AN EVALUATION OF THE
NAVAJO REFINERY WASTEWATER
TREATMENT FACILITIES, ARTESIA, NEW MEXICO

Prepared for
The New Mexico Water Quality
Control Commission
January 14, 1974

By
Earl Backenstow, P. E.
Water Quality Division
New Mexico Environmental Improvement Agency

FIGURE 2
 NAVAJO REFINERY WASTEWATER
 TREATMENT FACILITY
 HYDRAULIC PROFILE

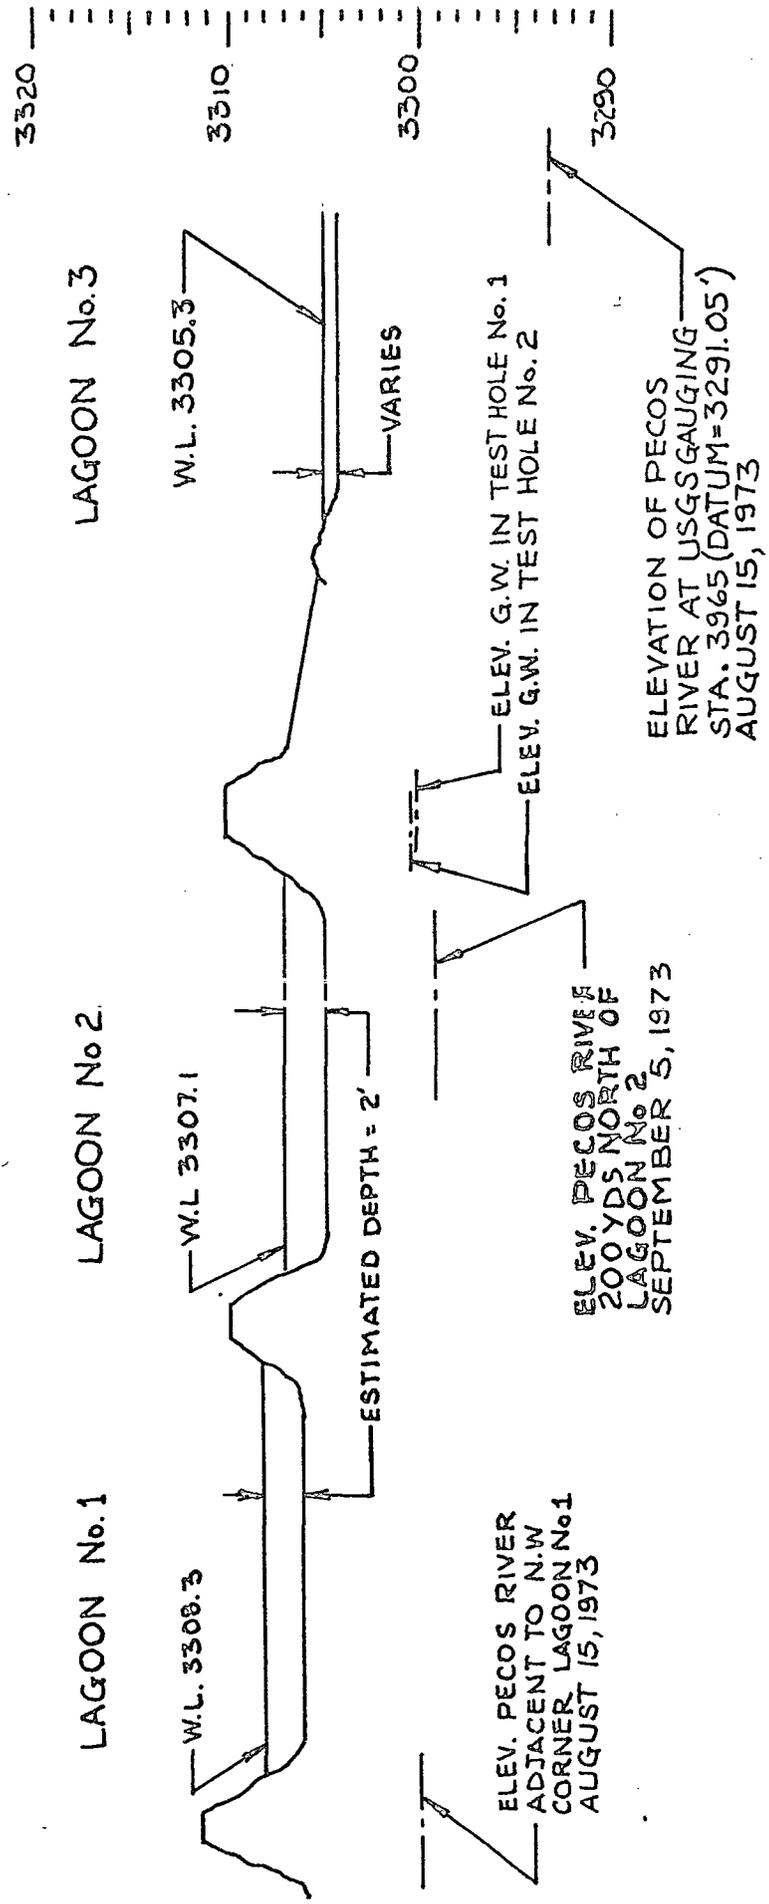
Groundwater test holes one, two, and three were dug to determine the depth of groundwater (reference Figure 1 for hole location). Depth to groundwater below the lagoon bottoms was determined to be five to six feet (reference Figure 2). The water in the holes was also sampled and tested for lead, chromium, and phenols. However, after consideration of the method by which the samples were collected, it was concluded that these data were questionable. Contaminants were undoubtedly introduced from the surface into the holes as they were being dug. The data are reported in Table III.

Lagoon three does not have any embankment to speak of. It is situated much lower than lagoons one and two. Comparison of river elevation data with the elevation of lagoon three shows that the lagoon is flooded routinely.

Effluent Ditch Looking Southwest
(Upstream) Catalytic Cracking Tower
at Refinery is in Background
(Location E)

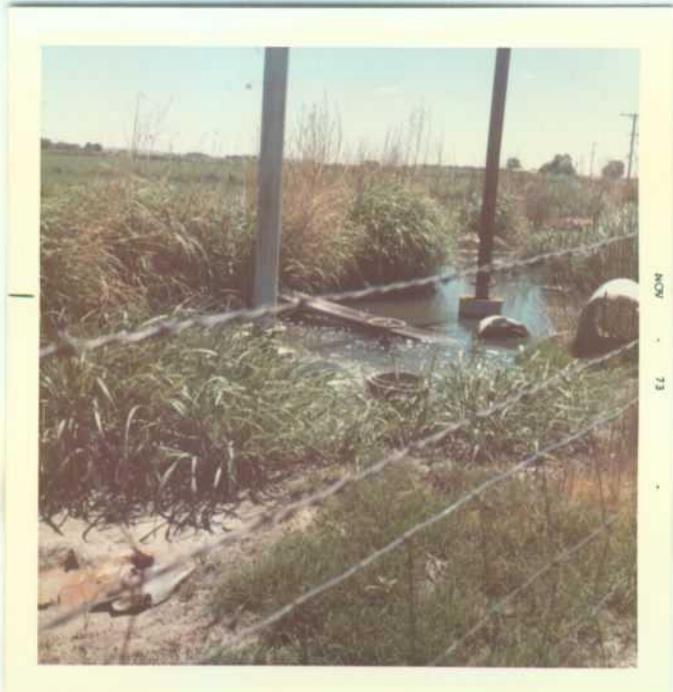
The refinery effluent ditch is very susceptible to spills and breaks. The writer walked the entire length of the ditch and took several photos of the ditch (reference Appendix C, photo locations B through K). Several areas were observed where small spills had occurred onto adjoining pasture-land. One of the photos taken at location E illustrates this. Some evidence of spills were also observed at location H. The photo taken at location I shows the concrete and steel constructed at the site of the December, 1972, spill to prevent any future spills at this location. The photo taken at location K shows a diversion in the ditch which was apparently constructed to bypass a spill problem area.

Area Adjacent to Effluent Ditch
Where Overflow has Occurred
(Location E)

In the writer's opinion, the spills from the ditch will continue to occur until the ditch is eliminated. It should be replaced by a pipeline completely protected from any exfiltration or infiltration.
